Water workshop held 24-25 February

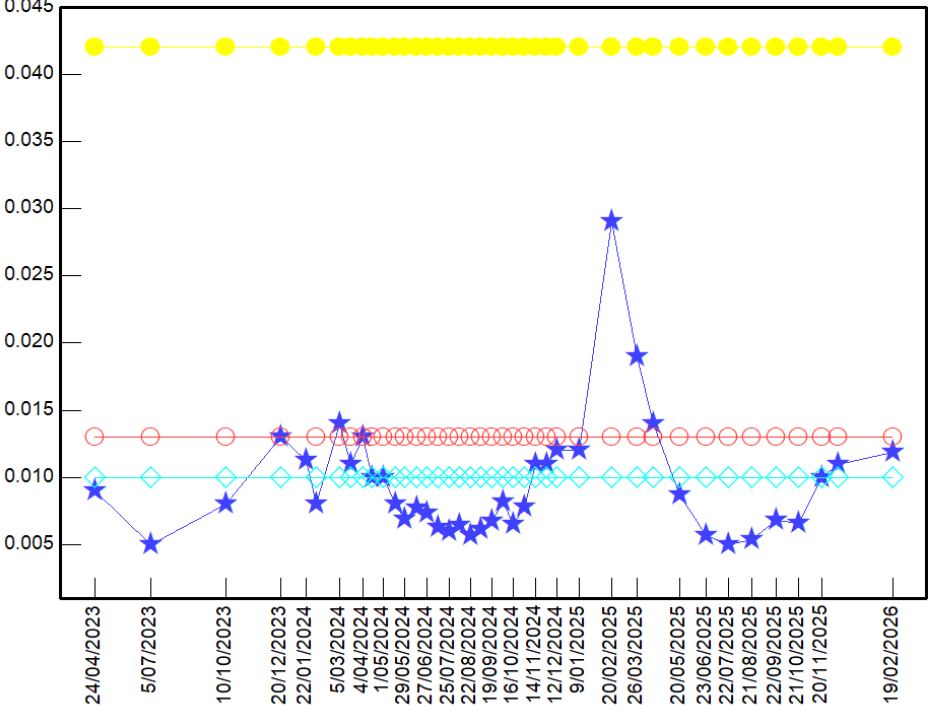
<p>As, Sb, Mo, SO₄ – limits for surface water compliance should be the same as GW limits.</p>	<p>Arsenic (As) The current proposed Surface Water (SW) limit is 0.042 mg/L Default Guideline Value (DGV) 90% Protection, Australian and New Zealand Guidelines for Fresh and Marine Water Quality (ANZG, 2018). The proposed As Groundwater (GW) of 0.01 mg/L Maximum Acceptable Value (MAV) NZ Drinking Water Standards is not achievable. RSO3 baseline arsenic data exceeds the proposed GW limit 0.01mg/L (see table and graph below). RSO3 baseline data also exceeds ANZG 2018 DGV 95% Protection 0.013 mg/L.</p>

RS01 Arsenic mg/L

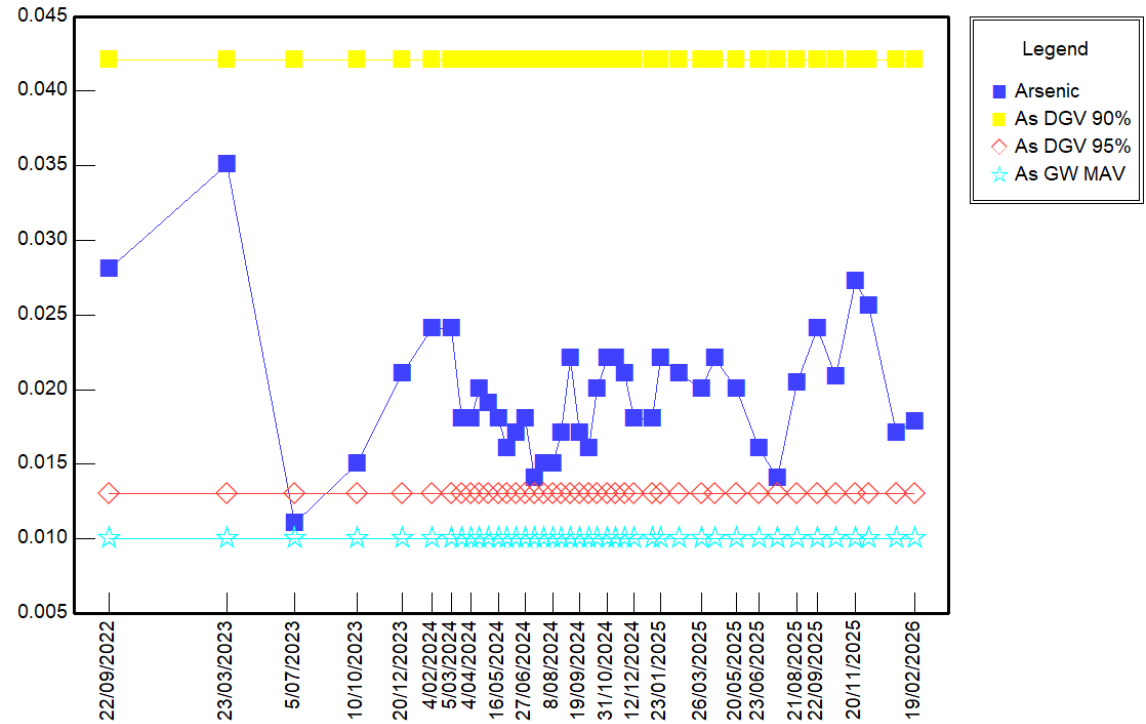
Present	Agreed Actions	Completed / Response																																			
		<p data-bbox="891 236 1984 288">RSO1 graph is also shown exceeding all limits except the proposed SW 0.042 mg/L. RSO1 is not a proposed compliance monitoring location.</p>
